Re: Site Plan Submission
Parkside Bible Church Addition
491 Eastern Boulevard

Attached to this email submission dated 01/29/2013 please find the pdf file of the revised Parkside Bible Church site plans. Hardcopies will be delivered by the morning of 01/31/2013.

New Expansion Project Parkside Bible Church

ISSUE DATE: 01/28/13 (Rev.-5)

SITE LAYOUT PLAN

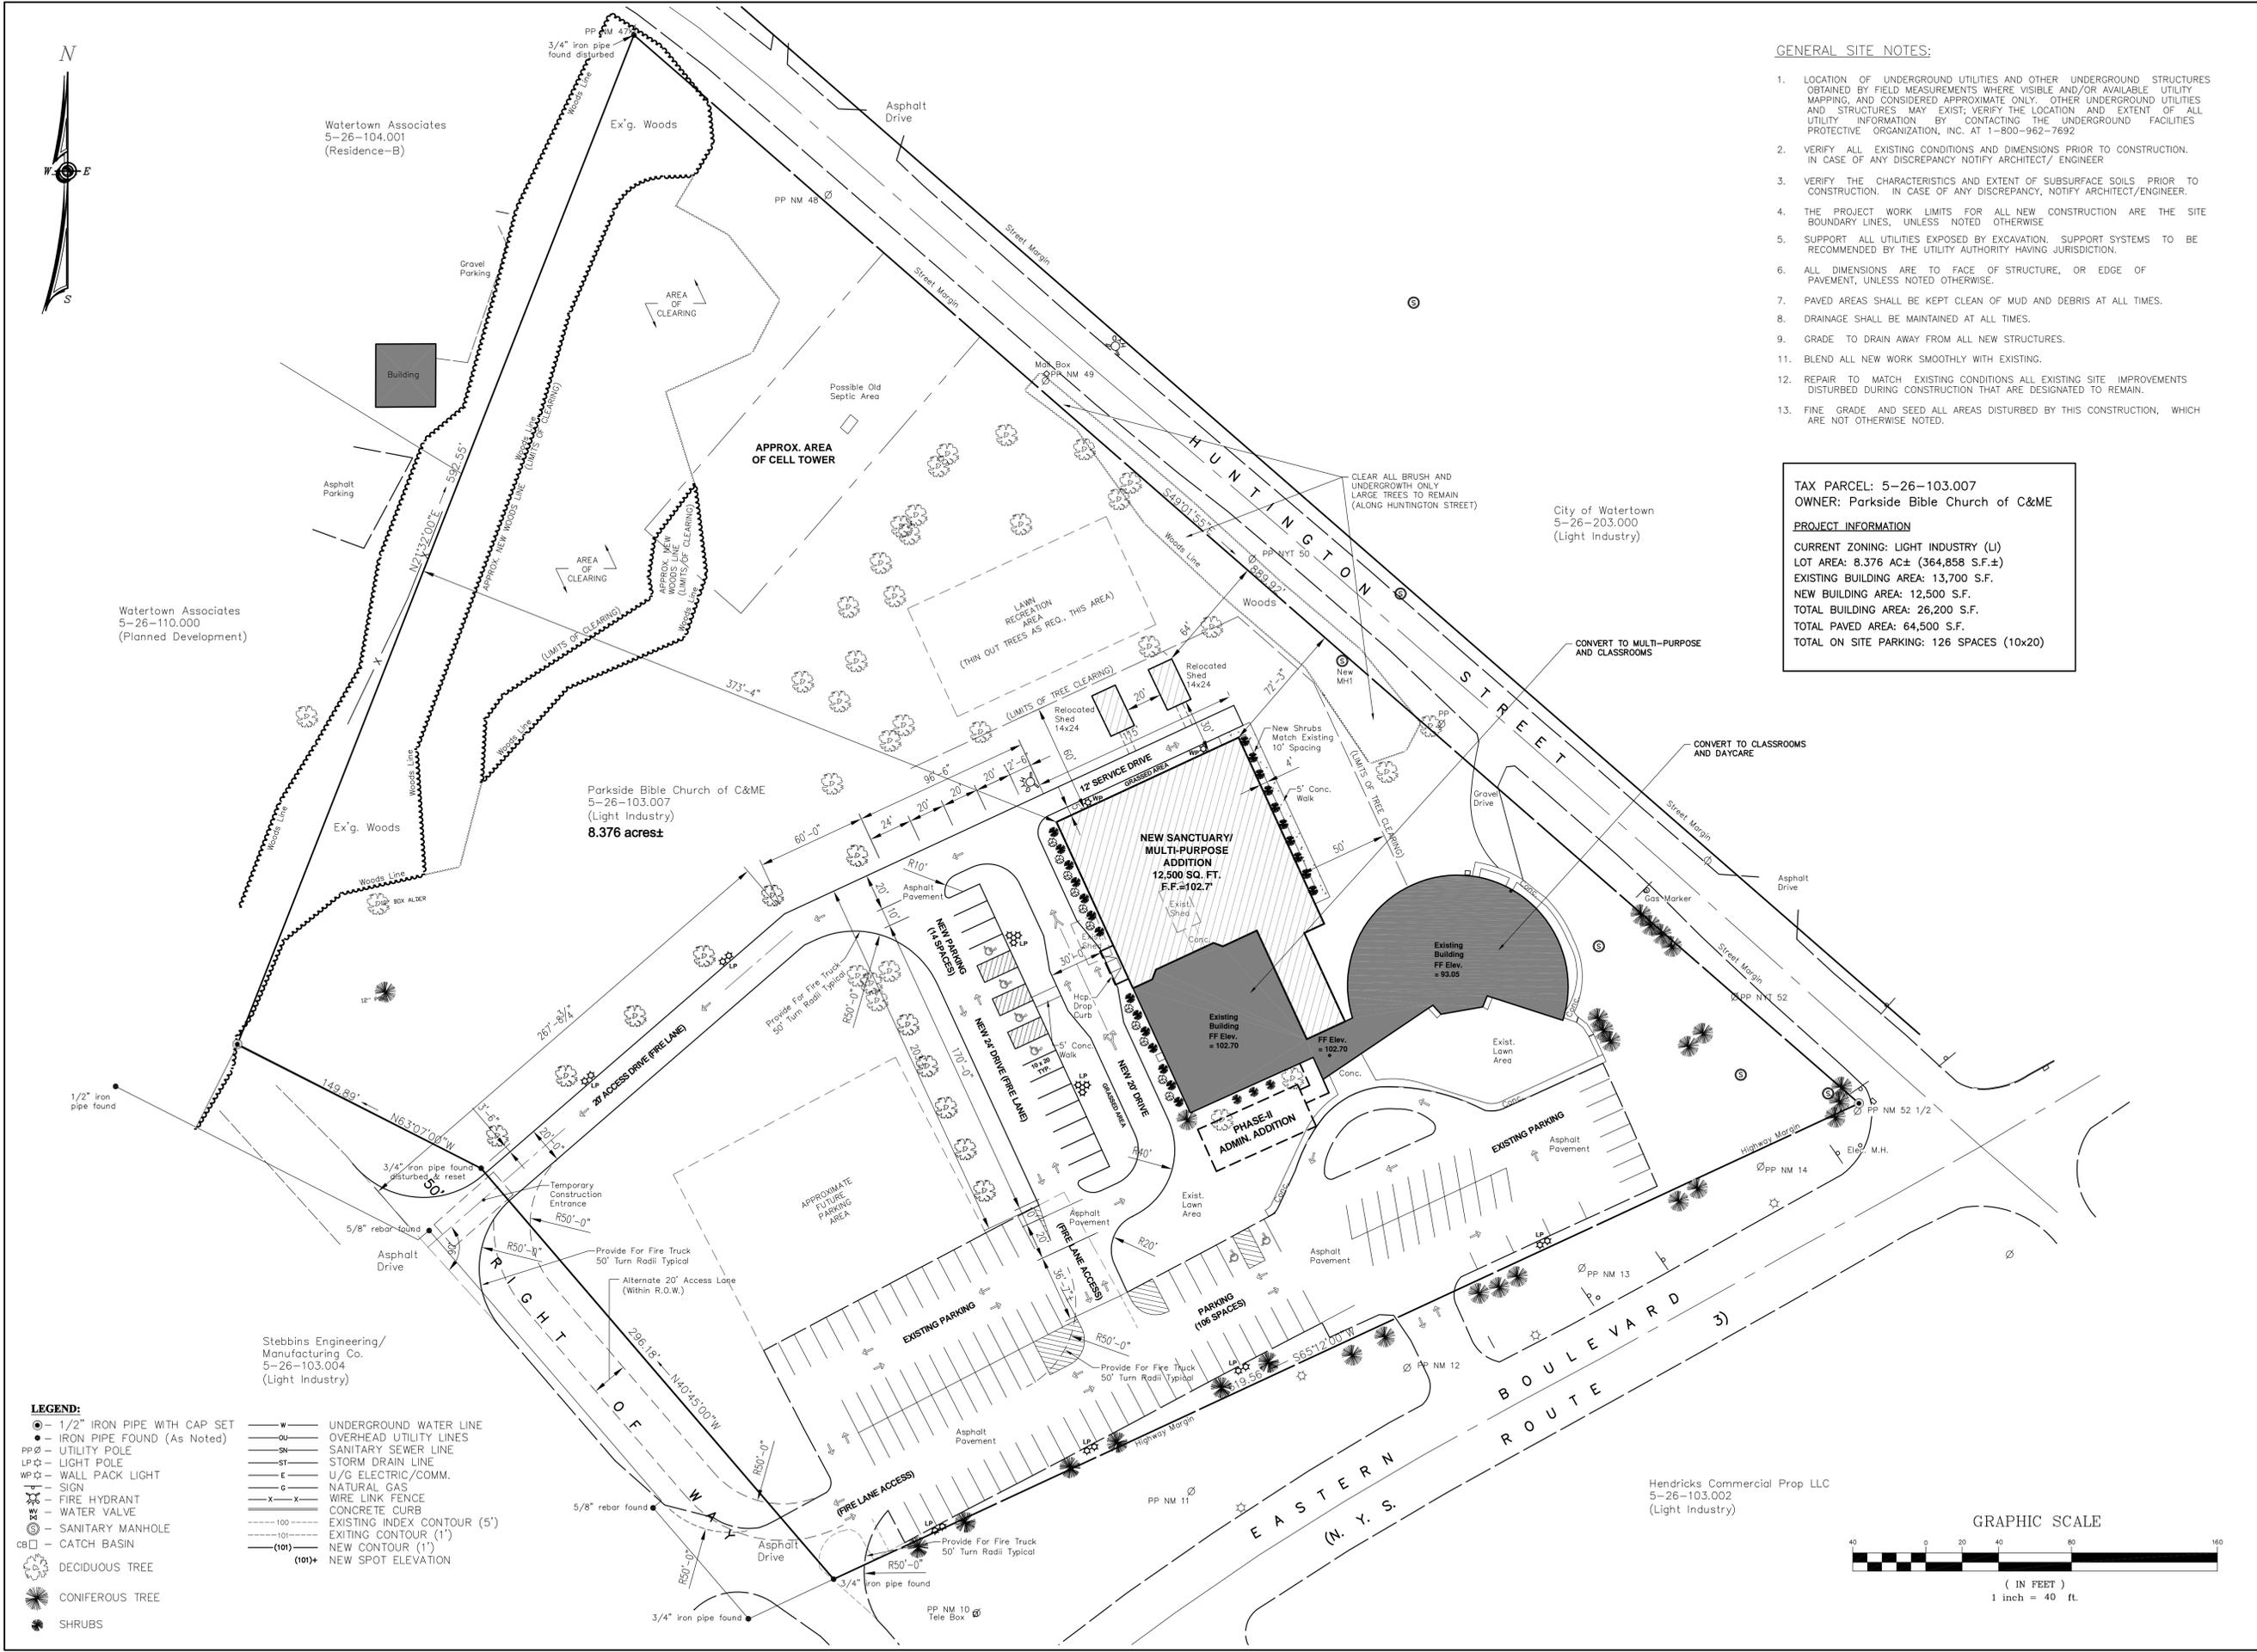
4. The applicant shall provide a Turn Movement Plan for Fire Truck Movements through the parking lot and drive areas. The minimum turn radius for the fire apparatus shall be 50 feet.

6. The applicant should modify the plans to prevent and mitigate the proposed mature tree loss including the reduction in the limits of the tree clearing area, the realignment of utilities, the relocation of the proposed parking area, the relocation of the proposed lawn recreation area, and retaining the natural screening along the Huntington Street right-of-way.

The turn movement plan with 50' radius is shown on C101.

The area behind the proposed building to be used for future recreation has been revised to show that it will be "thinned" only, rather than removing all of the large trees. See C101.

DRAWING NO.
C102
SITE LIGHTING AND UTILITY PLAN

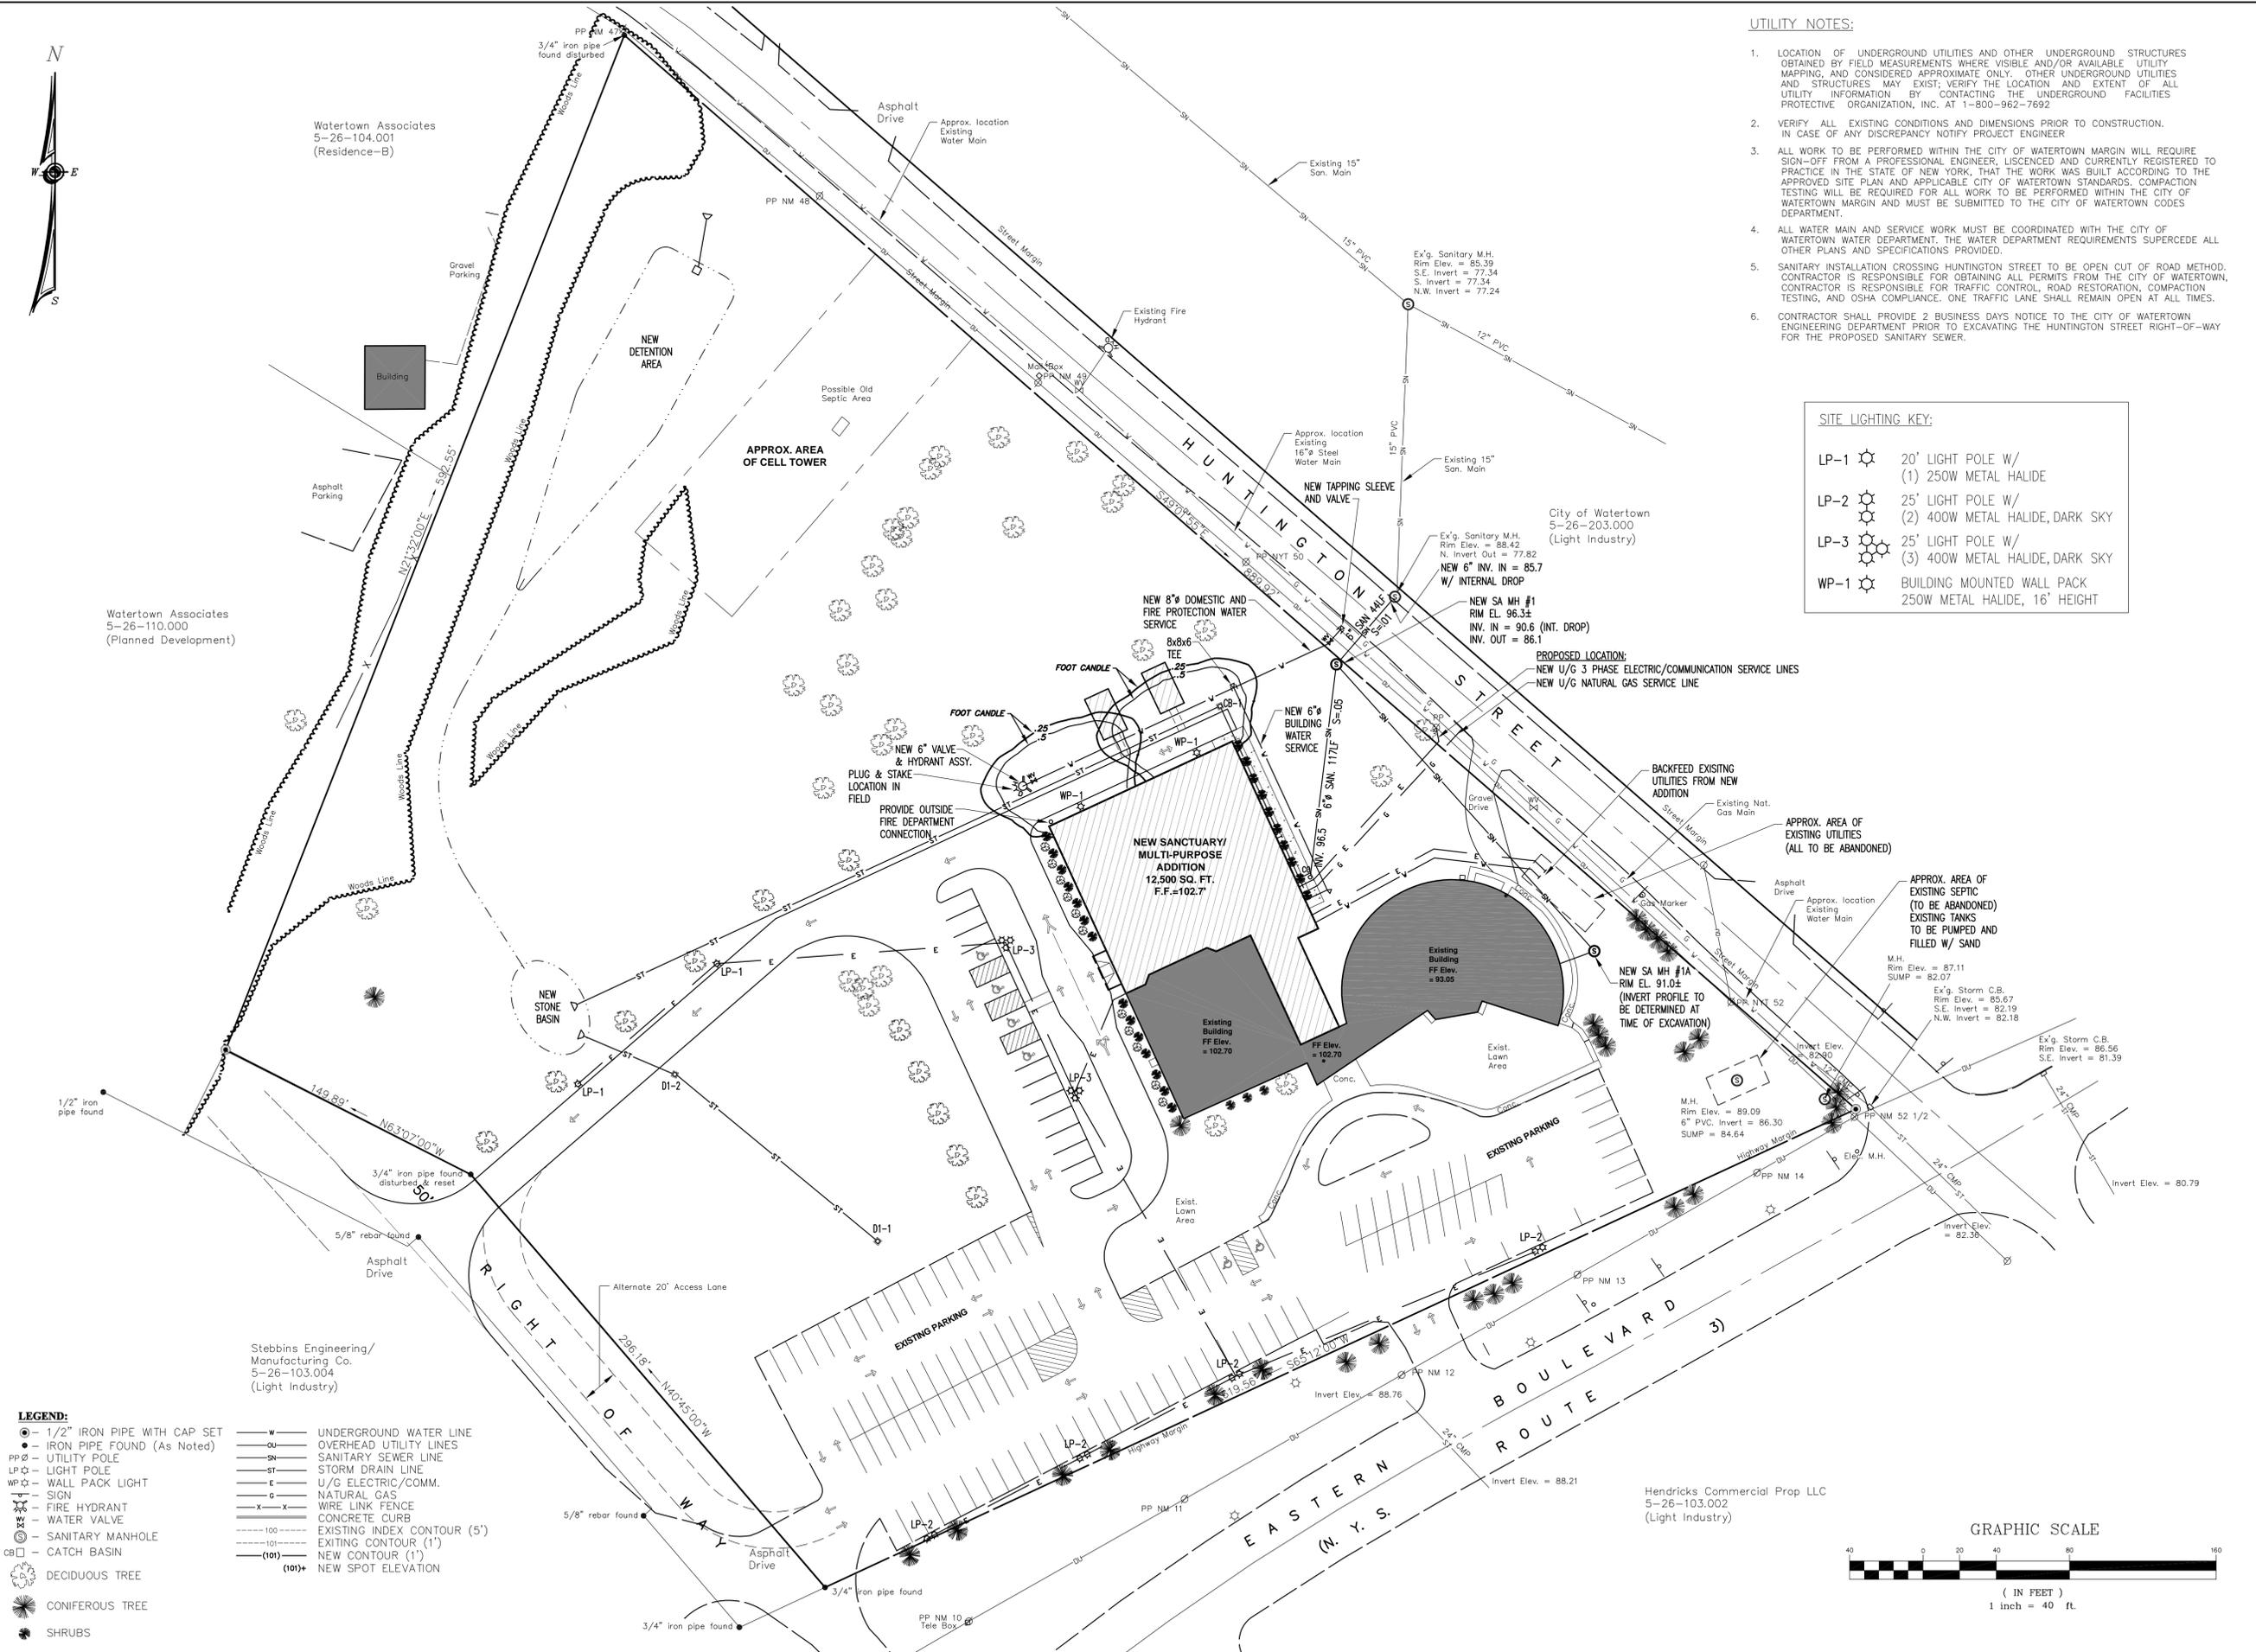
3. The applicant shall relocate the Fire Department Connection to be accessible from the proposed fire lane.

5. The applicant shall provide 2 business days notice to the Engineering Department prior to excavating the Huntington Street right-of-way for the proposed sanitary sewer.

The fire department connection has been relocated as shown on C102.

As noted on C102, two days notice will be provided.

Additional site lighting has also been added to the site plan, as shown on C102. Photometrics were not available at the time of this submission; however, photometrics will be provided prior to issuance of the building permit.
